RFQ NUMBER
 DEP14606

LINE	QUANTITY	UOP	CAT NO.	ITEM NUMBER	UNIT PRICE	AMOUNT
				ADDENDUM NO. 1		
				ADDENDUM ISSUED FOR THE PAINT CREEK WATERSHED RESTORATION PROJECT TO DISTRIBUTE THE SIGN-IN SHEETS, THE Q/A, THE REVISED SPECIFICATIONS, AND A REVISED DETAIL DRAWING RESULTING FROM THE 04/08/09 MANDATORY PRE-BID MEETING.		
				BID OPENING DATE & TIME ARE EXTENDED FROM 05/07/09 TO 05/12/09 AT 1:30 PM.		
				***** NO OTHER CHANGES *****		
001	1	JB		962-73		
				RECLAMATION: RESTORATION OF LAND & OTHER PROPERTIES		
				***** THIS IS THE END OF RFQ DEP14606 ***** TOTAL: _____

Req # DEP14606
Paint Creek Watershed Restoration
Addendum #1

PIPE BEDDING DETAIL

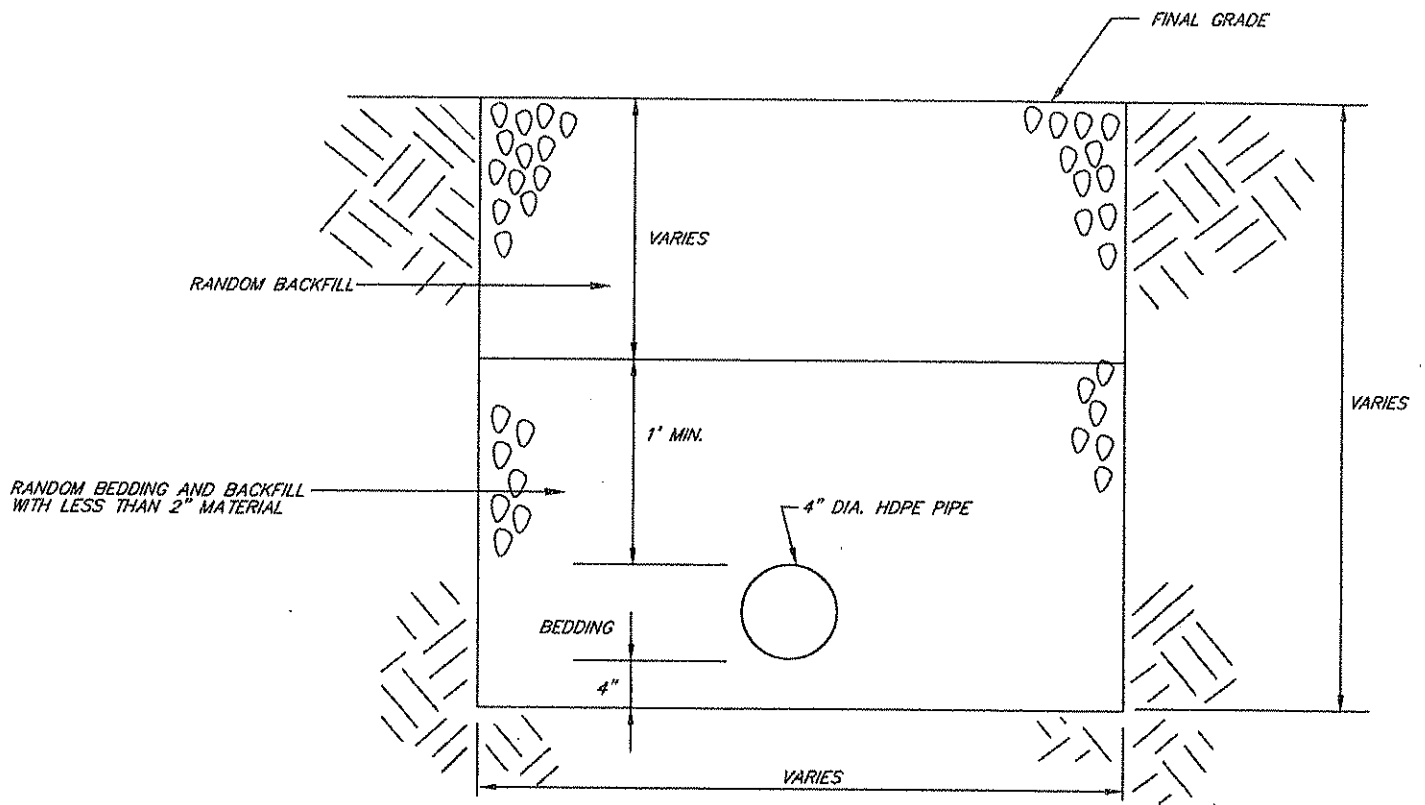
Add Specification 8.2.6 –“ Random Backfill: Random backfill shall be as specified in Section 604.8 of the WVDOT Standard Specifications for Roads and Bridges. The backfill considered for use must first be visually approved by the WVDEP.” (See attached detail drawing).

Specification 8.3.3 Feed Line/Cleanouts – Add: The feedline shall be bedded and backfilled as according to the details shown on the attached drawings and as approved by the WVDEP. The random material backfill shall be placed in loose lifts not exceeding twelve (12) inches and each lift compacted. Compaction of the material shall not be to less than 90% of maximum dry density as determined in accordance with ASTM D-698. The Contractor shall use special care in placing and compacting backfill maaterial to avoid damaging pipe. Frequency of density tests shall be one test per lift or as requested by the WVDEP.”

Q: What type material goes around the feedline?

A: See the attached drawing.
